SITE INSPECTION REPORT

Attention:	██████████	Date:	9/05/2022
Company:	City of Port Phillip		
Phone Number:		Inspection Date:	27/04/2022
Email Address:	██████████@portphillip.vic.gov.au		
Site Address:	39 The Avenue, Balaclava		
Job Number:	187501 PRJ725471	Client Reference:	
Instruction Description:	Structural Remediation of Roof Rafter

Figure 3. Remediation methodology of split rafters (no.1 shown). Proposed rafter behind split rafter not shown.

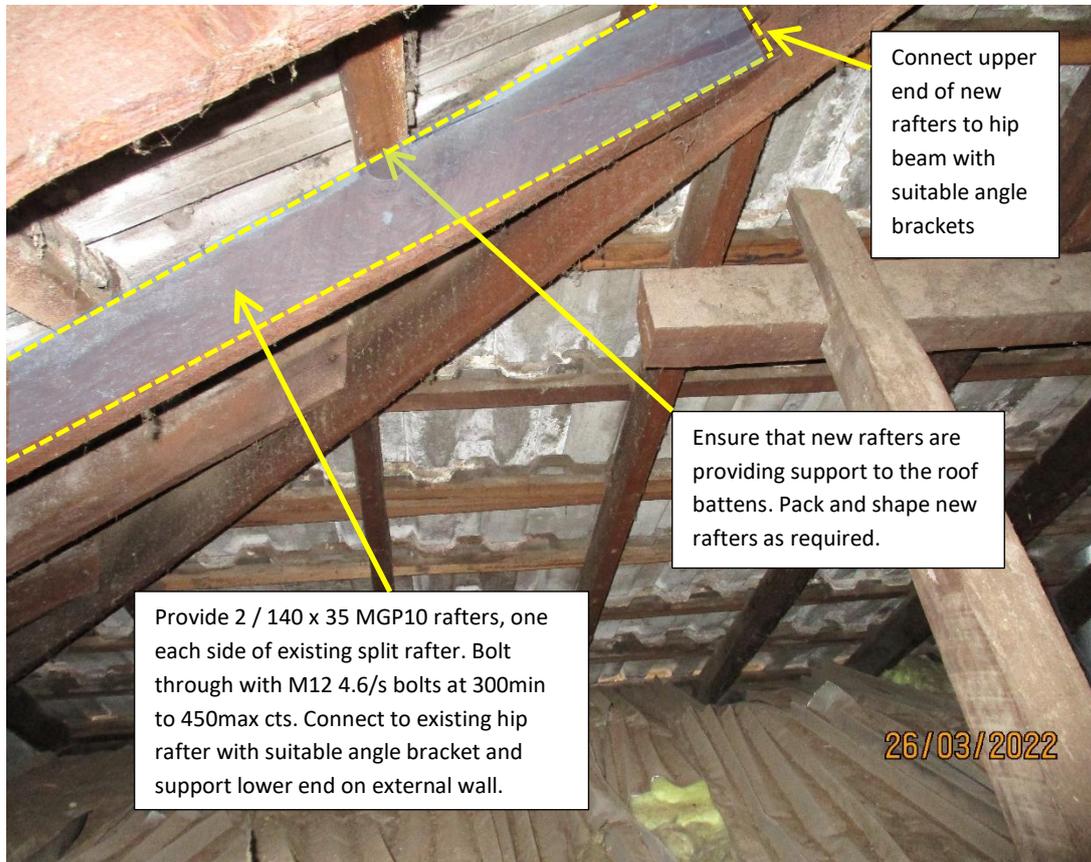
Notwithstanding that the split rafters was not observed, review of photograph 29 and 30 in the RZ Report is deemed sufficient for the purposes of this report. Photographs 29 and 30 indicate that remediation of the split rafters is required and that a practical method of remediation would comprise augmentation of the split rafter. The split rafter shall remain in place and additional rafters at either side of the split rafter shall be installed.

The span of the existing rafters is estimated to be a maximum of 2.5m with a maximum load width of 750mm. Based on these dimensions, it is recommended that both split rafters are augmented with 2 / 140 x 35 MGP10 rafters, one each side of the existing split rafter. The new rafters shall provide support to the roof battens, therefore packing and shaping of the new rafters may be required. The new rafters shall be connected to the hip rafter with suitable angle brackets at the higher ends and shall be supported upon the external wall at the lower ends. The new rafters and the existing split rafters shall be bolted together using M12-4.6/s bolts at 300mm min to 450mm max centres (refer to Figure 2).
